Request for Review

"Generation of electricity from 6.25 MW capacity wind mills by Sun-n-Sand Hotels Pvt. Ltd at Soda Mada Rajasthan " (0447)

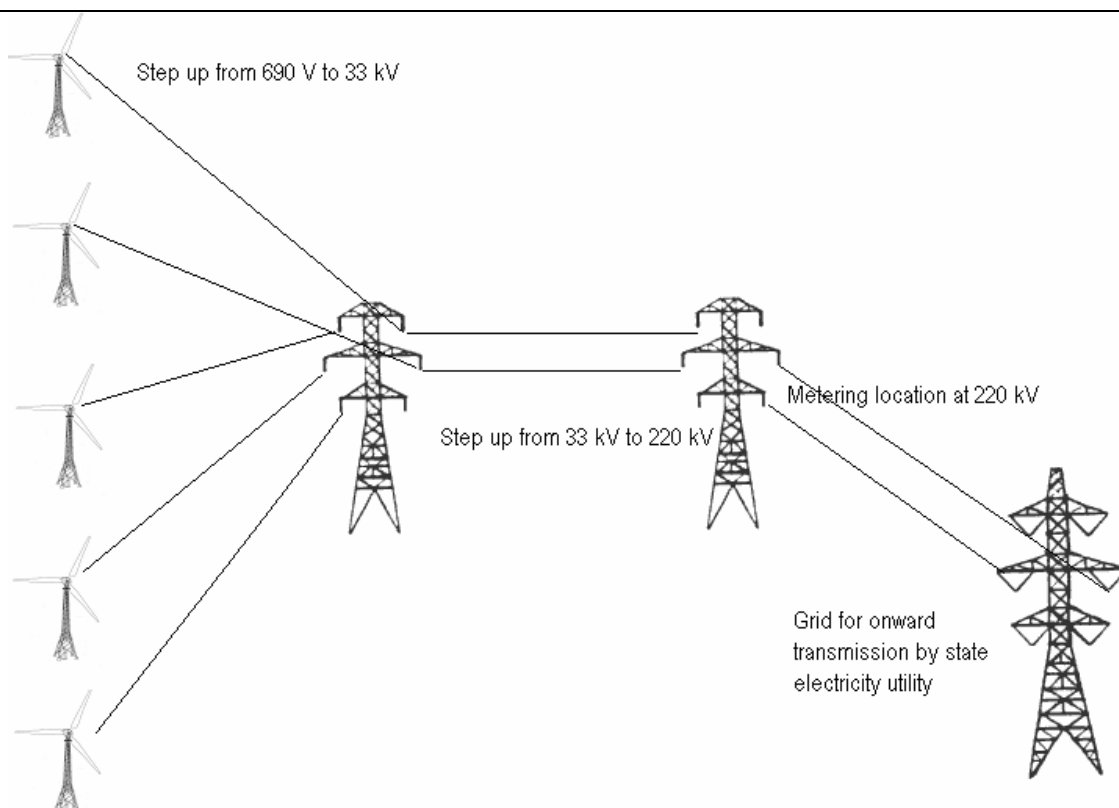
Request for Review	
Issue raised by EB Members / DNA	<p>EB Member: The project participant has not conducted the monitoring in accordance with the registered monitoring plan. The monitoring report should contain data on the output of each wind turbine (EGgen) and calculated data on auxiliary consumption and losses. Instead the emission reductions have been calculated using the meter readings from the uploading station. The monitoring report should be revised to be in accordance with the monitoring plan.</p> <p>The monitoring was not conducted in accordance with the registered monitoring plan. The net electricity generation should be calculated as the difference of metered generation at each wind turbine and auxiliary consumption and losses, rather than from the meter readings at the export point. Although the DOE has identified the reporting of electricity generation from the export point as a notational error and accepted the revised monitoring report on the basis of correction of the notations used, it should also address the source of data.</p> <p>Minor issue:</p> <p>QA/QC procedures are not appropriately developed in the PDD and in monitoring report. The PDD states that the development of QA/QC procedures is planned, but nothing is said about when it will be ready.</p>

Response of project participant	<p>Sun-n-Sand Pvt. Ltd.:</p> <p>Preamble:</p> <p>The electricity generated from 6.25 MW registered CDM project is sold to the state electricity utility (RRVNL – Rajasthan Rajya Vidyut Prasaran Nigam Limited). The state electricity utility is responsible for metering the generated electricity by following the grid code of the state of Rajasthan (grid code is available at http://www.rajenergy.com/gridcode.htm) by establishing two meters namely main meter of 0.2 accuracy class & check meter of 0.5 accuracy class respectively.</p> <p>In addition to this the project proponent (investor / owner of wind turbines) is also responsible to absorb the losses from the generation point (wind machine) until the grid interconnection point (sub station). These losses include the line losses from point of generation to the point of metering and the transformer losses (two stage step up process from 690 V to 33 kV and from 33kV to 220 kV).</p> <p>Also since the machines come to stand still (halt) during non availability of wind (lean season) and during planned and unplanned maintenance, they will draw current from the grid during initial phase of operation from stand still condition (auxiliary consumption of electricity). Thus the grid code has made provisions for metering system adopted at wind sites to measure both import and export of electricity. This is required to measure the exact amount of electricity produced by a wind machine against which the state electricity utility is liable to make payments to the investor / owner of wind machine.</p> <p>The diagram below further explains the arrangements at site:</p>

Explanation of diagram:

- Generation at machine controller: 3 phase 4 wire 690 volts
- First transformer at individual machine: Step up from 690 V to 33 kV (Step up losses)
- Transmission from machines to grid interconnection point (transmission losses)
- Second transformer before grid interconnection point: Step up from 33 kV to 220 kV (Step up losses)
- Metering location: Metering as per the grid code of Rajasthan by the state electricity utility as per the set of specified main & check meters with calibration as per schedule of the state utility.
